# AVIONS PIERRE ROBIN

## BULLETIN SERVICE N°143 / SERVICE BULLETIN N°143

#### OBJET PALONNIERS

#### SUBJECT RUDDER BAR

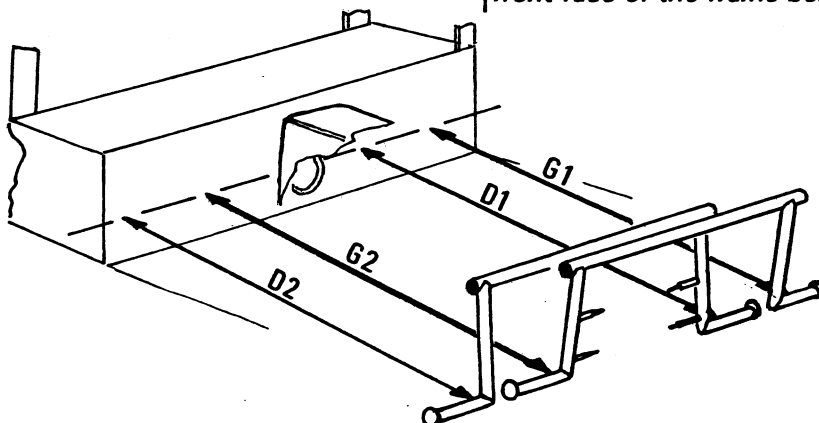
Maintenir les palonniers au neutre et effectuer une mesure de chaque tube d'appui du même palonnier, par rapport à une référence fixe (face AV du caisson de sièges).

Si la différence entre G1 et G2 ou entre D1 et D2 est égale ou supérieure à 10 mm

Si la différence entre G1 et G2 ou entre D1 et D2 est comprise entre 5 et 10 mm

*Steadily maintain the rudder bars in neutral position and measure the dimensions between the foot tubes of the same rudder bar and a transversal reference: front face of the frame box located under the seats.*

If the difference between G1 and G2 or between D1 and D2 is equal to or upper than 10 mm

If the difference between G1 and G2 or between D1 or D2 is between 5 and 10 mm

Remplacer les palonniers G réf. 27.23.05.010  
D réf. 27.23.05.020  
par les palonniers G réf. 27.40.31.010  
D réf. 27.40.31.020

Effectuer les mêmes mesures de contrôle à la prochaine visite de 100 h, puis toutes les 500 h

Replace the L rudder bar ref. 27.23.05.010  
R rudder bar ref. 27.23.05.020  
by the L rudder bar ref. 27.40.31.010  
R rudder bar ref. 27.40.31.020

Perform the same measurements at the next 100 h visit, then every 500 h
